**E8361A-10****S E R V I C E N O T E**Supersedes:  
NONE**E8361A PNA Series RF Network Analyzers****Serial Numbers:** US00000000 - US43140947**Add-on mechanical components to enhance instrument reliability****To Be Performed By:** Agilent-Qualified Personnel or Customer with specific product repair knowledge – requires instrument disassembly and component replacement.**Parts Required:**

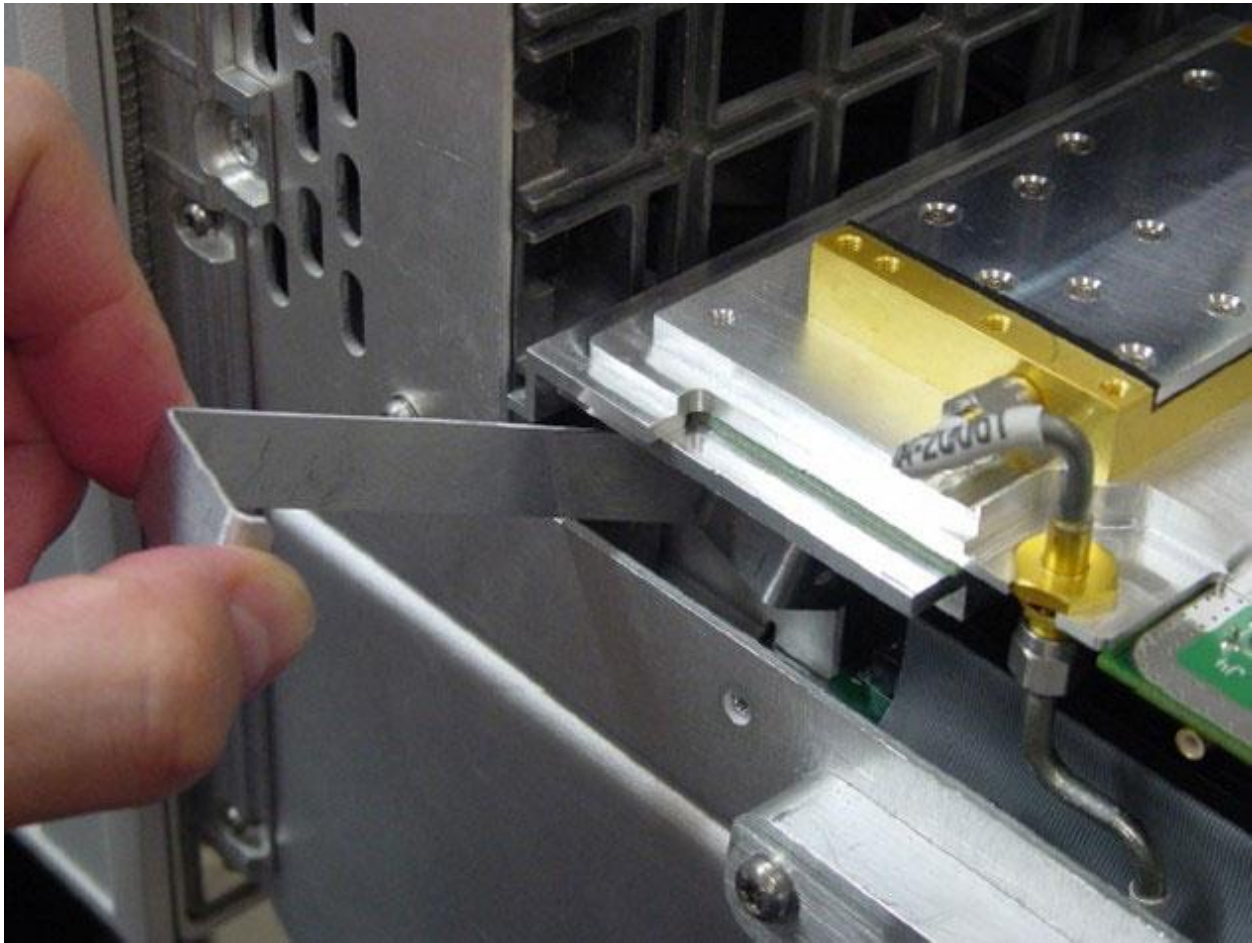
- a. Remove and discard existing screw near ribbon cable connector on System Motherboard. See below.

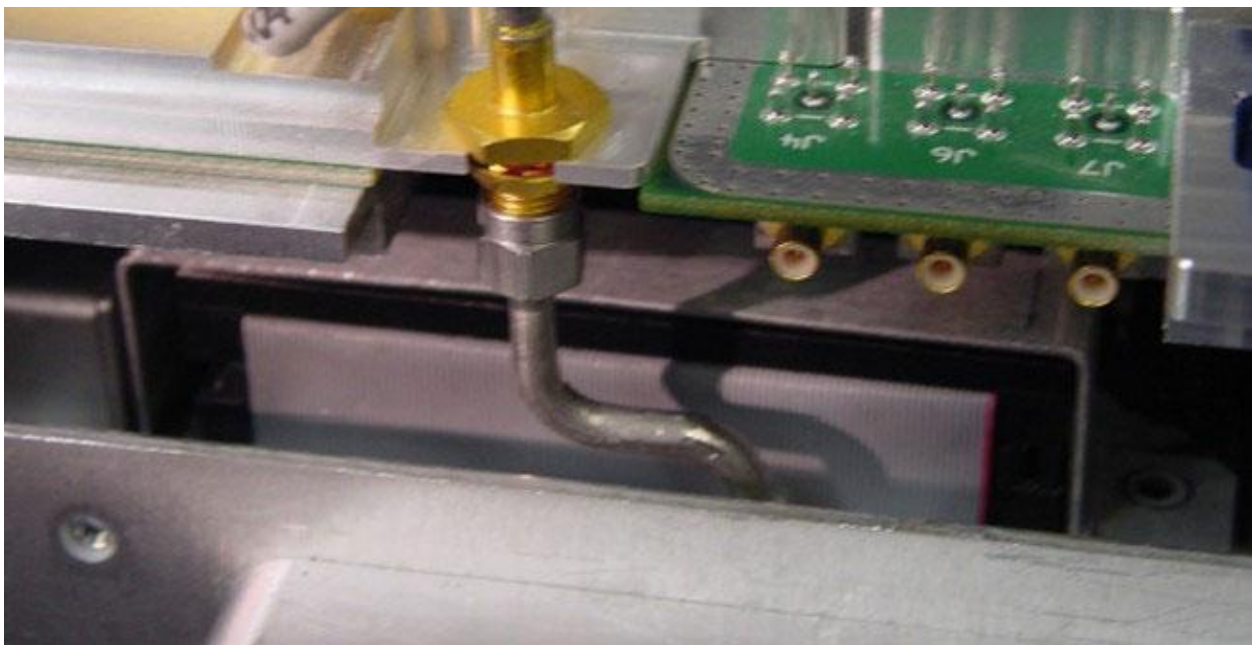
- b. Insert Ribbon Cable Clamp under Source Assembly as shown.

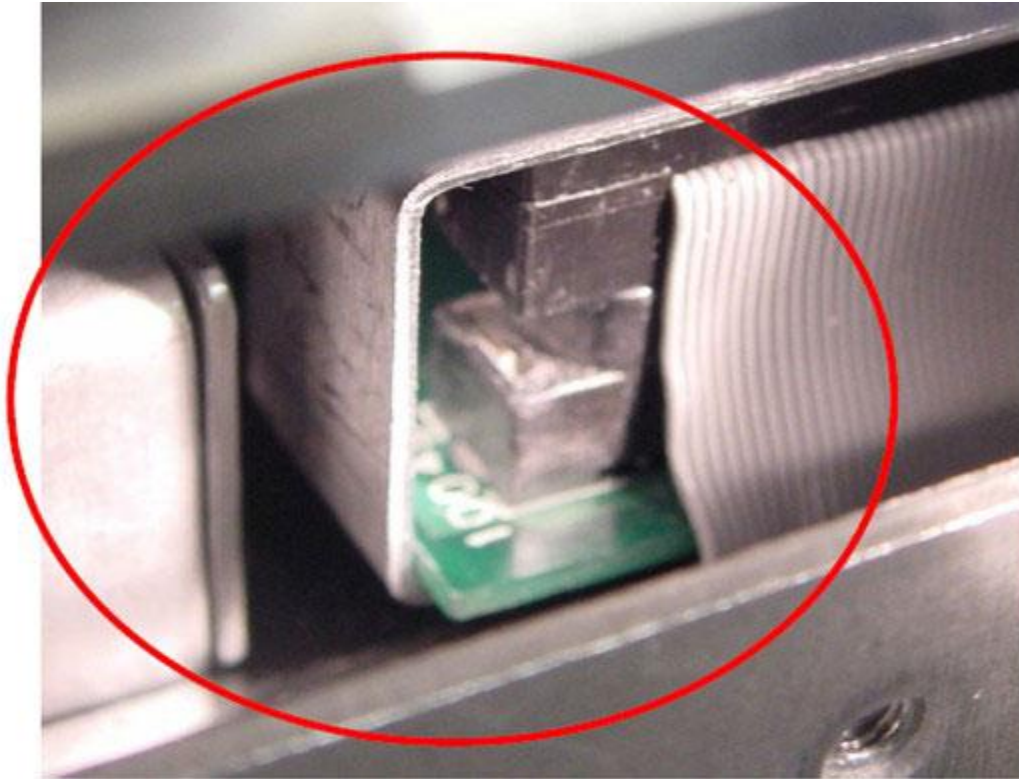
- c. Position the clamp over the Ribbon Connector. Use needle nose pliers if necessary to slide the clamp into place. Ensure that the edge of the clamp is parallel to the connector and not skewed.

**NOTE:** Ensure that the Clamp Lip is secured **BELOW** the edge of the System Motherboard

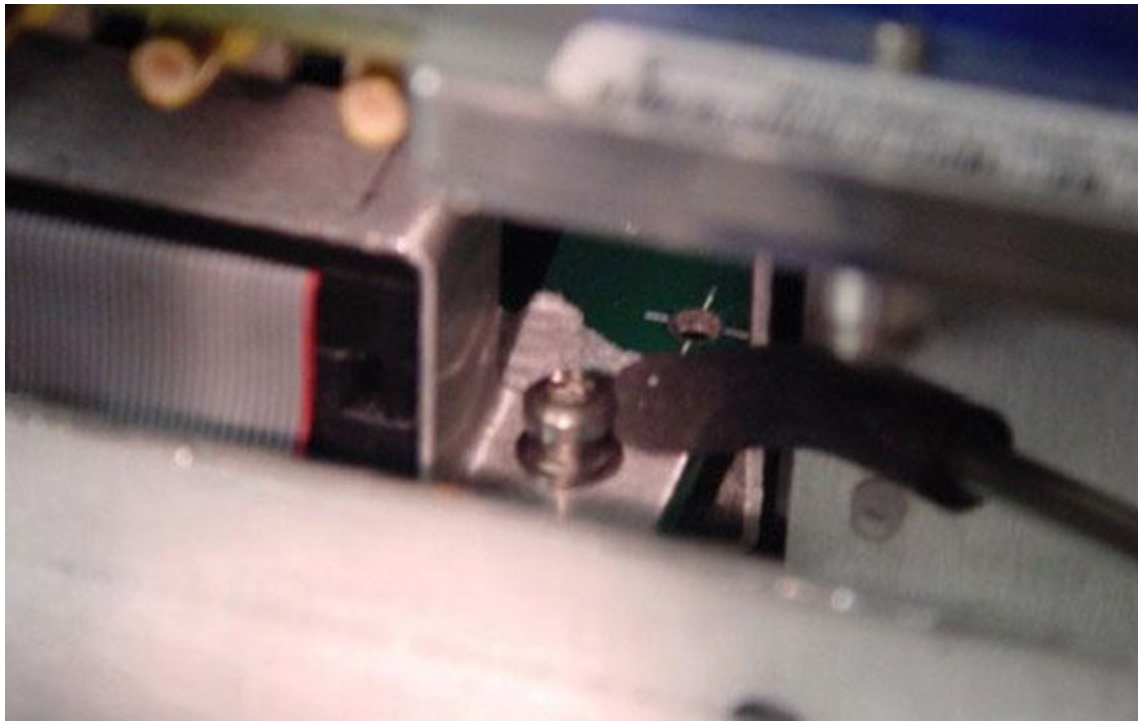
- d. Using tweezers, install a new 0515-0374 screw through the hole in the bracket.

- e. Use a nut runner tool (T-316130) or alternatively a clean erasure end of a pencil to help run the screw.

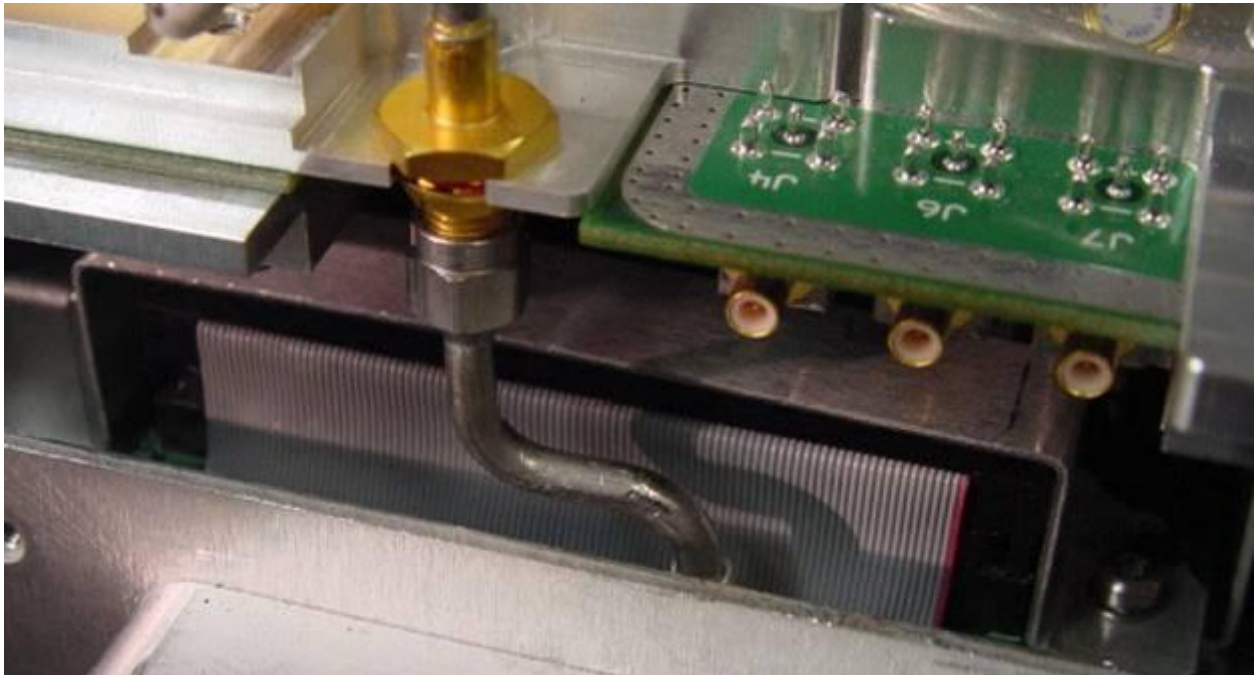
- f. Secure screw using the modified 10 lb-in breakaway wrench.

- g. This image shows the final position of the secured clamp.

**Enhancement Issue No.2 (Applies to all models and options)**

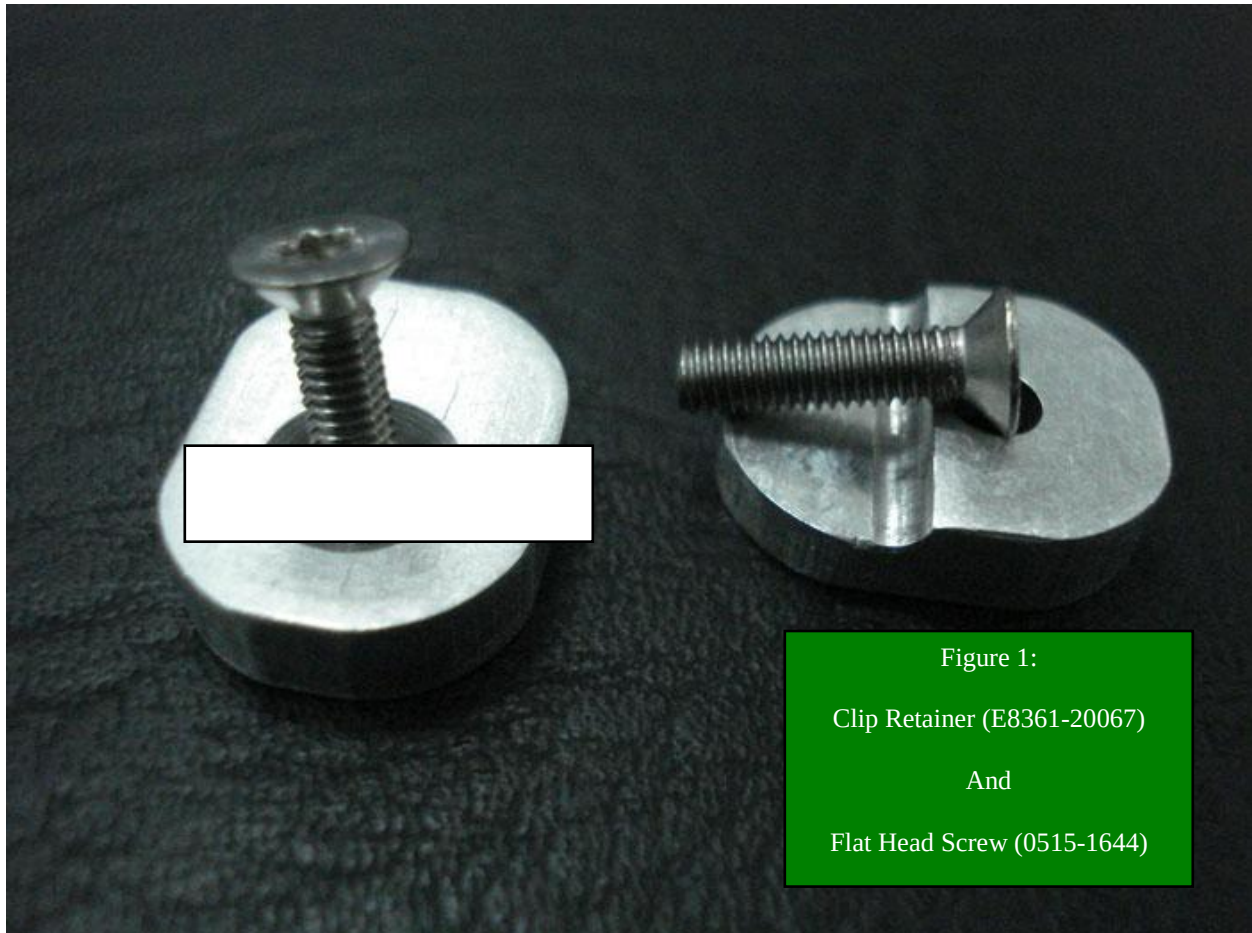
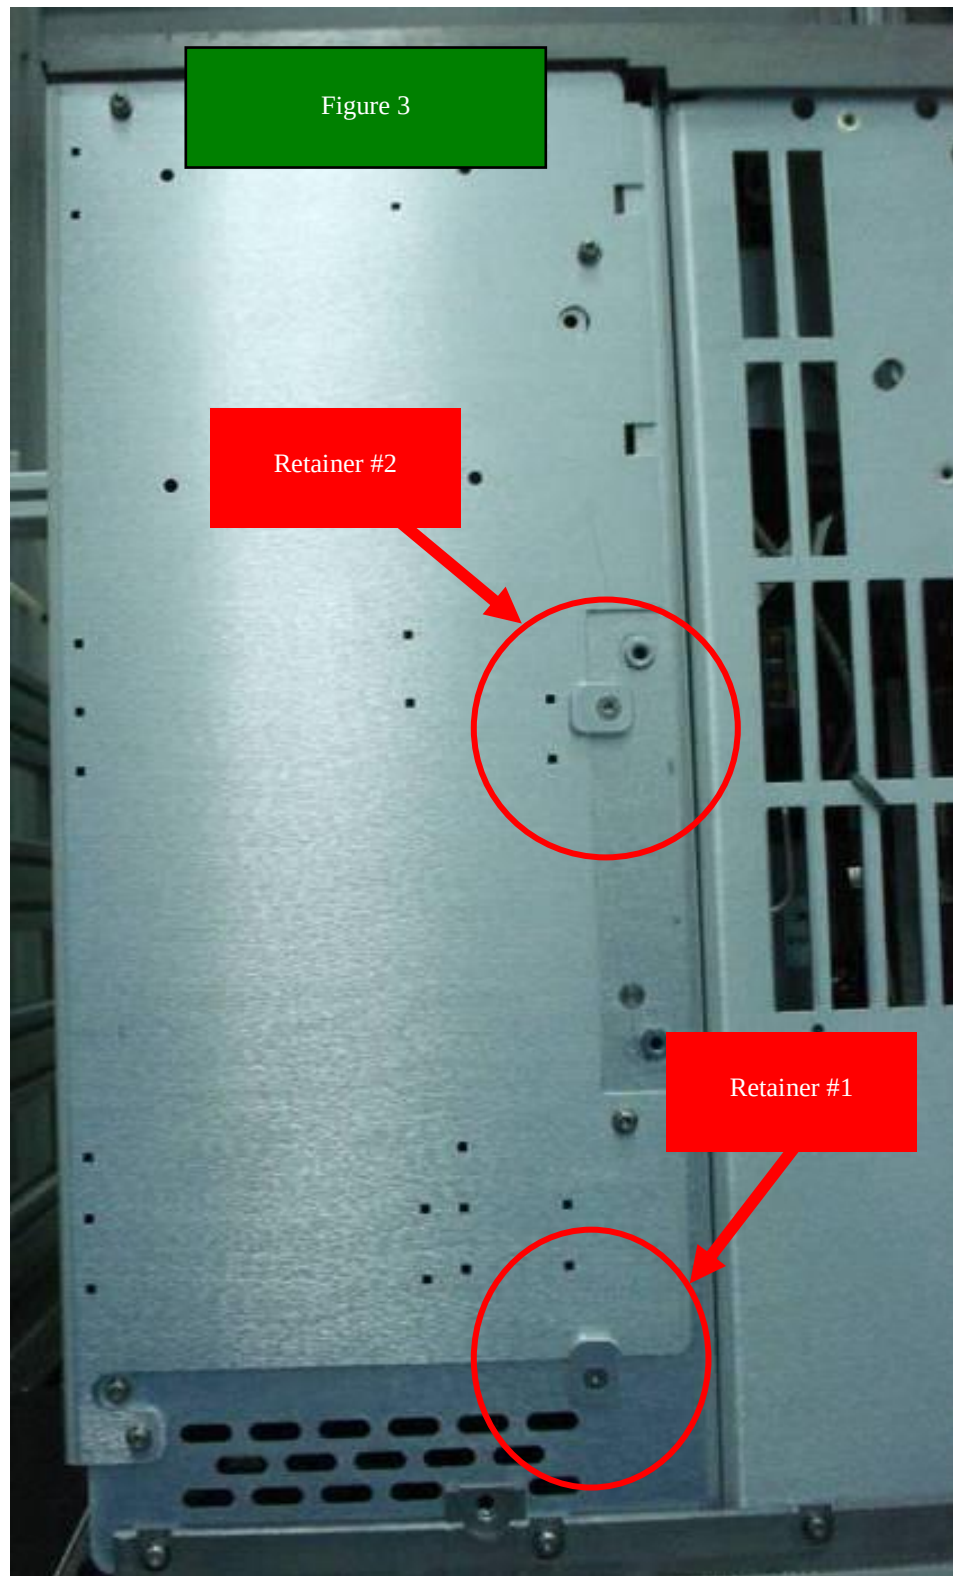
The Clip Retainer (E8361-20067) to be secured with Flat Head screw (0515-1644) in 2 places at 9 lb-in. This Retainer Clip may naturally rotate a bit when being secured, which is acceptable. Note that the existing screw needs to be removed and discarded prior installing Retainer Clip #1 (shown below in Figure 2a, 2b, and 3).
